Grey District Council
C/- Perspective Consulting Ltd

Re: LU3154-23 Request for Further Information

Kate McKenzie
Principal Planner
Tai Poutini Resources Ltd

Figure 1: Fuel Tank Location

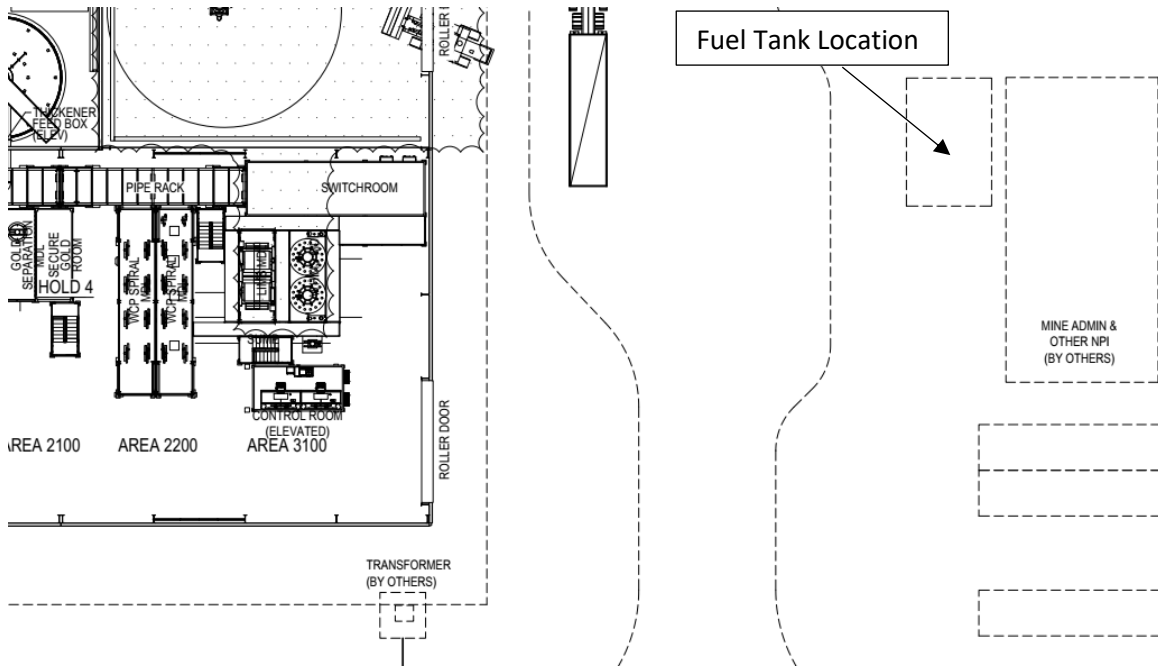
6. Please confirm the location of the proposed 40,000-litre diesel storage tank on the site.

The proposed diesel storage tank is located in the office area adjacent to the plant. Please see the diagram below.
